Revision	Revision Description	Rev. Date
1	CCD #2	7/10/15

**ACCESSIBLE ENTRY RAMP**  
**PIONEER ELEMENTARY SCHOOL**  
 BAKERSFIELD CITY SCHOOL DISTRICT  
 4404 PIONEER DRIVE BAKERSFIELD, CA 93306

Release: -CCD #2

**ENLARGED SITE PLANS**

**ENLARGED SITE PLAN**

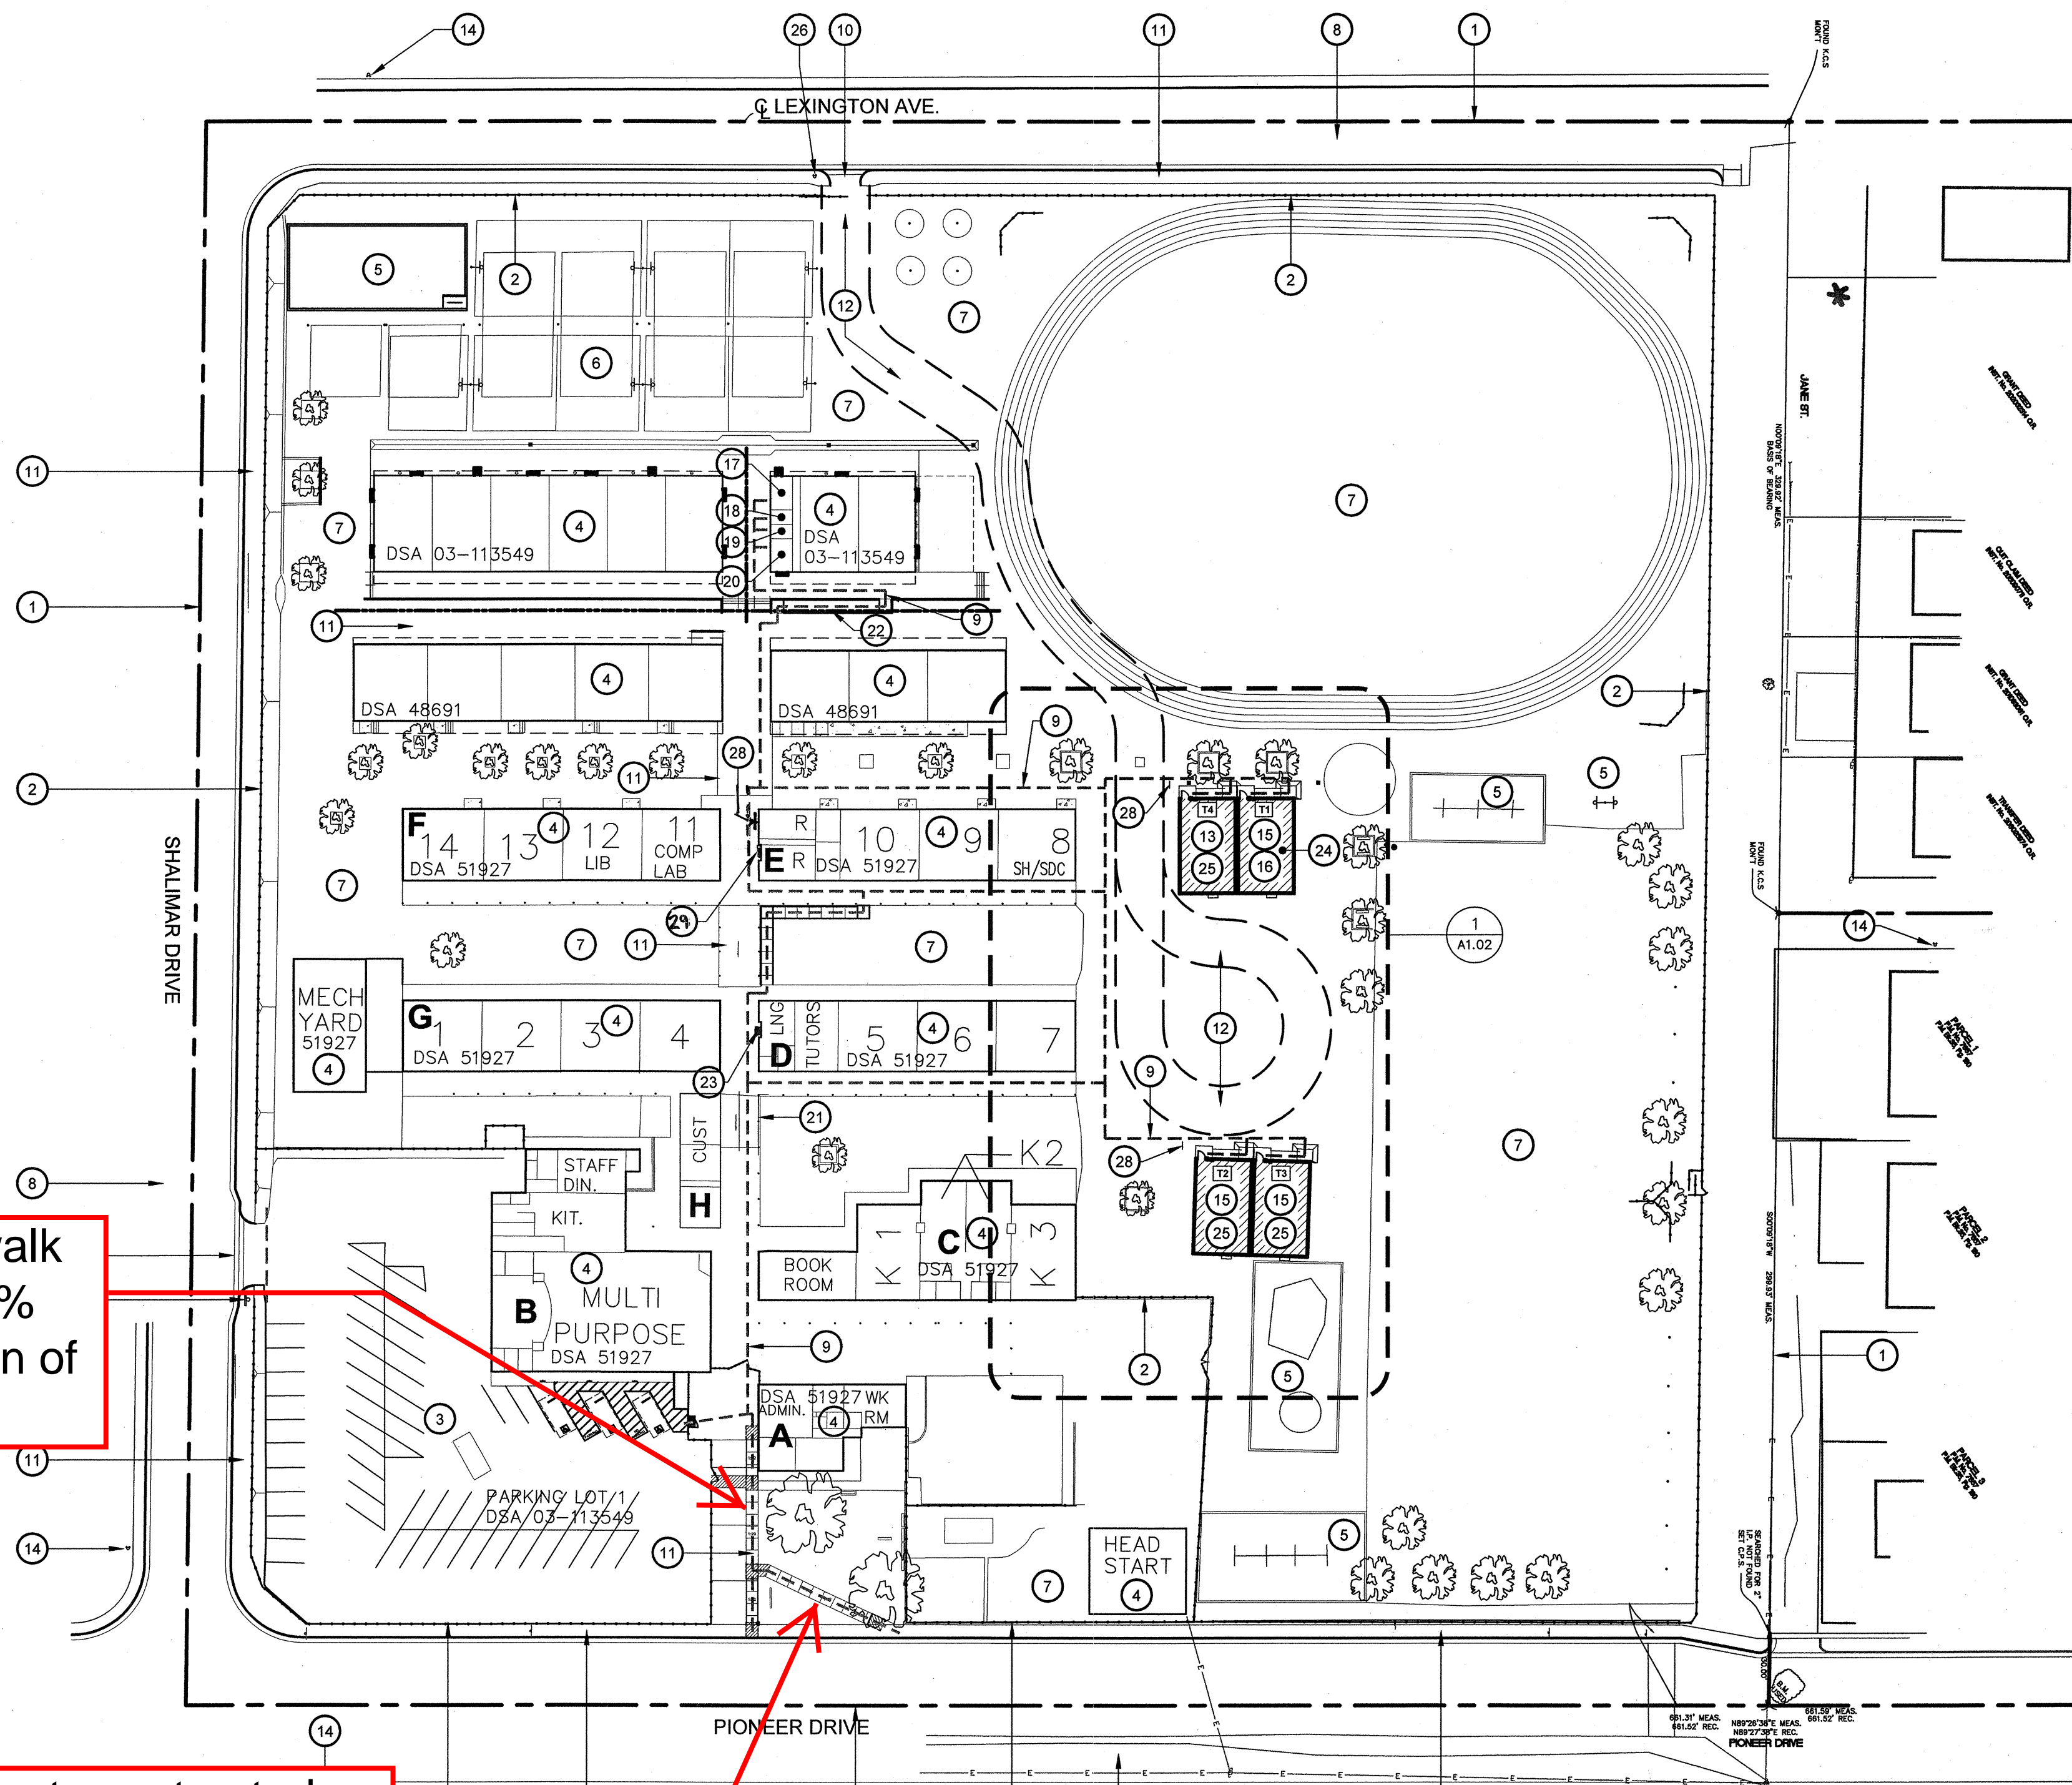
This concrete walk is too steep, >5% slope in direction of travel

This walk was not constructed because the grades are too steep. The resulting walk would not be compliant. This CCD provides an accessible path of travel to the public way.
